**HIGHLAND BRIDGE ROWHOMES – 4<sup>th</sup> ADDITION**  
**Pulte Homes**

FINAL PLAT  
April 19, 2022

The following information is in response to the April 6, 2022 preliminary approval letter. Some questions/comments were included in this letter.

## EASEMENT DETAIL

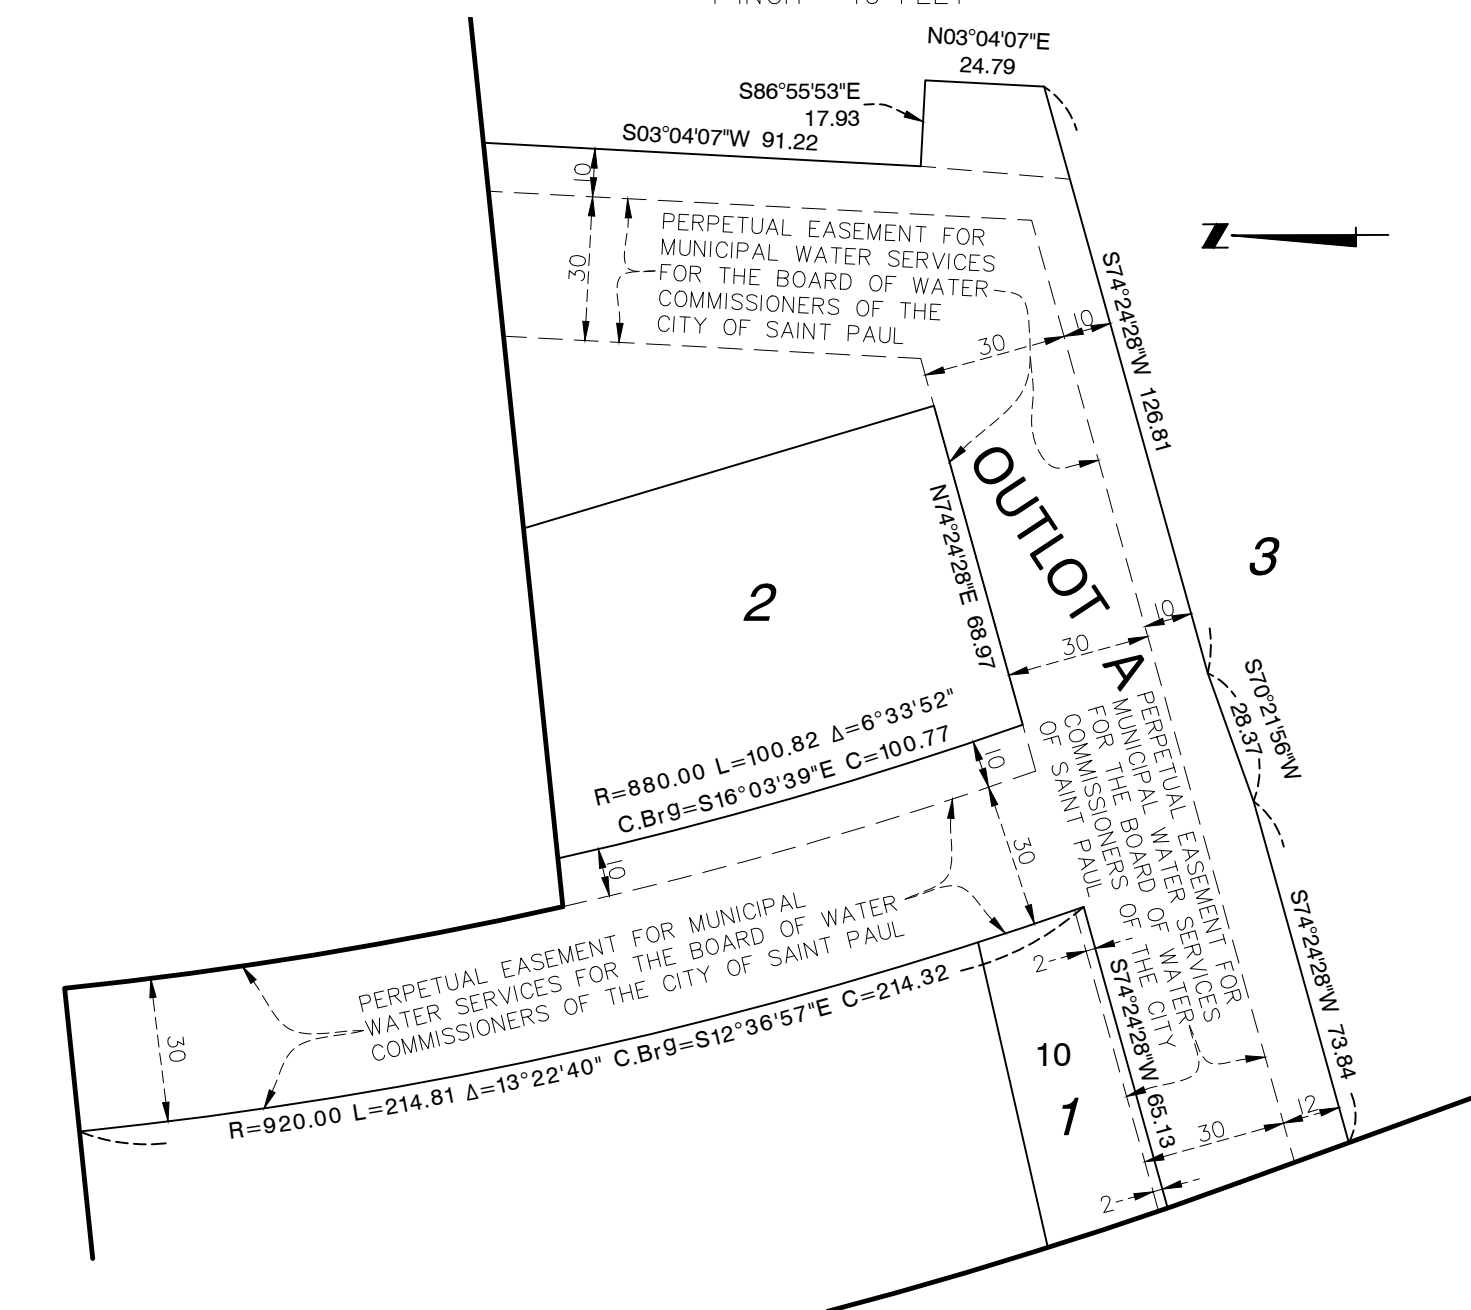
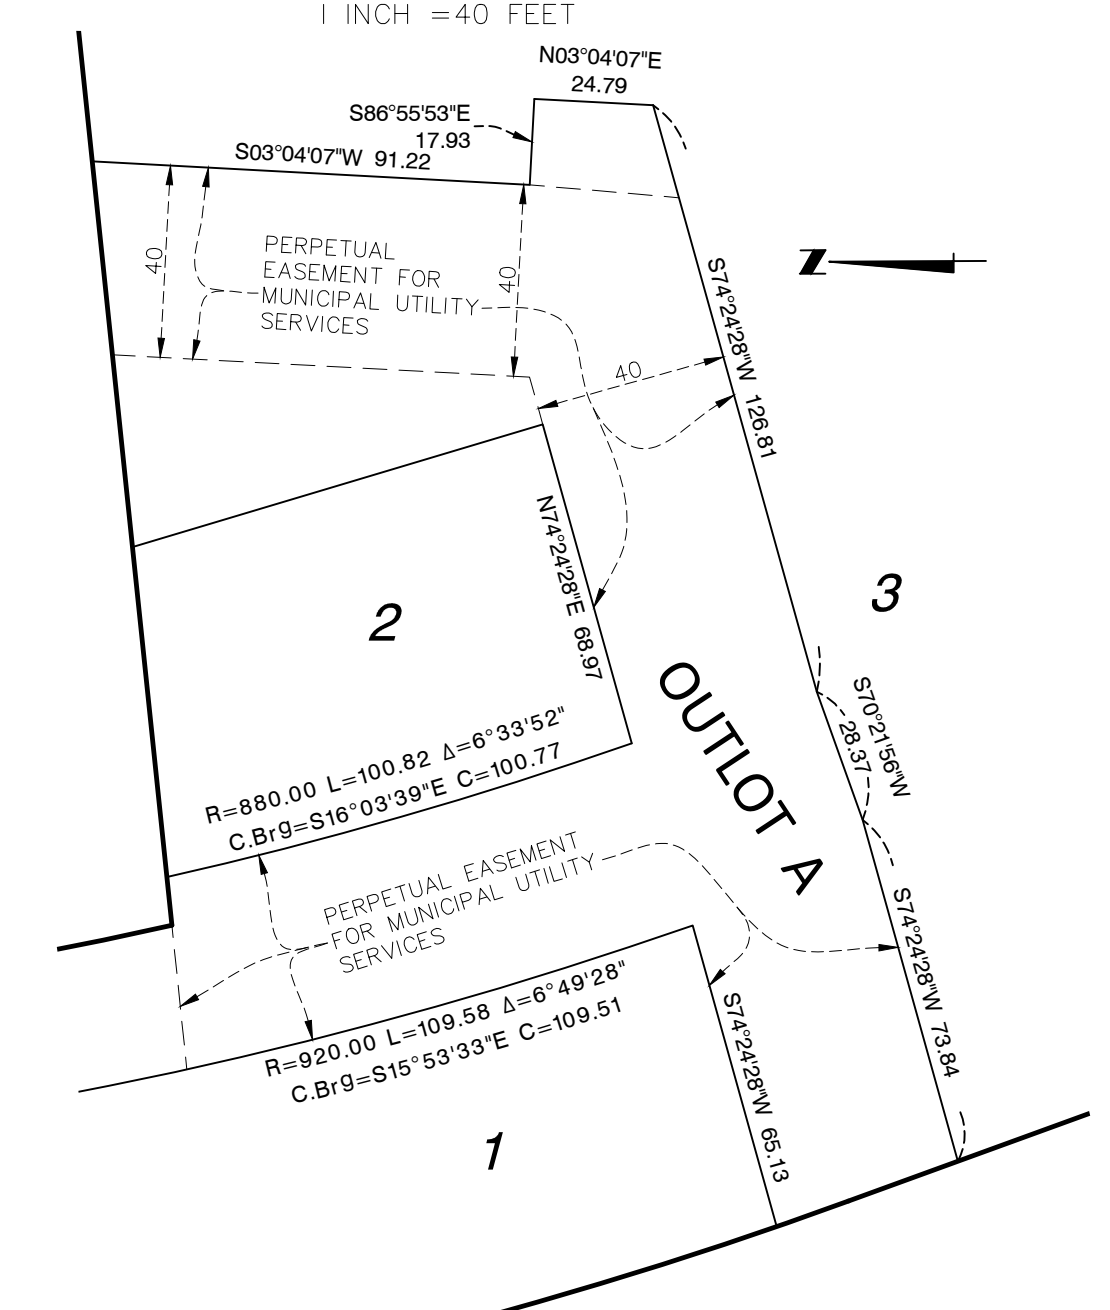
**19. Why is the shared municipal utility and water easement only 30’?**

The revised plat shows the existing easement through the Lot 1 property as well as on our Lot 2 property.
